Hornsea Project Four

Applicant's comments on other submissions received at Deadline 5

Deadline 5a, Date: 4 July 2022 Document Reference: G5.30

The following 2 images show the overlap in disturbance contours for high order (26 km Effective Deterrent Range (EDR)) and low order (5 km EDR) UXO clearance as an illustration of potential overlap with bottlenose dolphin areas of usage. Image 1: shows 2 km and 3 km

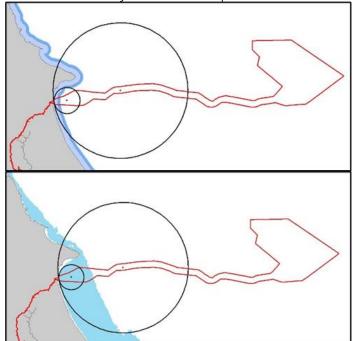
to the wider surrounding area. Natural England request that further			
	consideration is given now to drivers of seasonal variations in the wider			
	spatial distributions of auks, particularly during August and September, to			
	determine the potential importance of this area.			
Tab D – Marin	e Mammals			
D1	The Applicant has provided examples of density estimates for the CES MU,	As requested, the Applicant has provided a list of, pur	ely illustrative	and highly conservative,
	which are an order of magnitude higher than the GNS MU. The Applicant	impact estimates using different bottlenose dolphin	densities in the	table below:
	maintains that there is no evidence to suggest that these density estimates			<u></u>
	are comparable to the areas of bottlenose dolphin presence along the	Density approach	Density	
	northeast English coast.		#/km²	
		Uniform density in Greater North Sea (GNS)	0.003	
	Whilst we understand that there is limited evidence, we are still concerned	Management Unit (MU)

that the GNS MU density estimate is not suitably precautionary as it doesn't	Uniform density in Coastal East Scotland MU	0.0104

Reference	Stakeholder's Written Representation	Applicant's Resp	onse			
	account for the known increased presence of bottlenose dolphin at the	Uniform density	within 2 km	of the mainla	nd coast	0.1102
	coast, which have been linked to the CES MU.	within CES MU				
		Uniform density	within 3 km	of the mainla	nd coast	0.0803
	We would be supportive of the Applicant using a higher density estimate for	within CES MU				
	the portion of habitat along the northeast English coast that meets the	Uniform density	within 25 m	depth conto	ur of the	0.1044
	typical usage patterns of bottlenose dolphin in the CES MU (i.e. within 2 km,	mainland coast	within CES M	1U		
	3 km, and 25 m depth contour). We understand that this assessment would					
	be purely illustrative, and highly conservative, but it would give an indication	The following is o	a table of res	ults for the ir	npact of un	exploded ord
	of the worst-case number of animals impacted should density estimates be similar to the CES MU.	assuming differer	nt bottlenose	dolphin dens	sity estimate	es:

buffers from land. Image 2: shows 25 m depth contour.

Reference	Stakeholder's Written Representation	Applicant's Response
		Irrespective of the density estimate used, the number of bottlenose dolphin predicted to experience PTS from high order UXO clearance (800 kg) is <1 dolphin. This impact is of negligible magnitude and thus not significant.
		Irrespective of the density estimate used, the number of bottlenose dolphins predicted to experience disturbance from high order UXO clearance (26 km EDR) is low (up to 39 dolphins, even under these worst-case and unrealistic density assumptions). Therefore no significant impact is expected.
D2	The Applicant has provided further information in support of their position to not mitigate the full SELcum PTS zone and only mitigate the SPLpeak PTS zone. NE do not agree that the information provided by the Applicant is sufficient to justify their position, and maintain that the SELcum PTS zone must be taken into account when determining appropriate mitigation measures to reduce the risk of injury. We acknowledge that there are limitations to the assumptions used in modelling of SELcum PTS, however mitigation of solely the SPLpeak distance	The Applicant is in agreement with Natural England that there is ongoing active research into the area of cumulative PTS and as such, better methods for estimating cumulative PTS distances are expected to become available in the near future. The Applicant agrees that any such new methods should be taken into account when finalising the mitigation measures in the final MMMP post-consent. The Applicant is willing to accept that mitigation of cumulative PTS should be based on the latest research and methods available at the time of the final Marine Mammal Mitigation Protocol to best estimate cumulative PTS impact ranges.
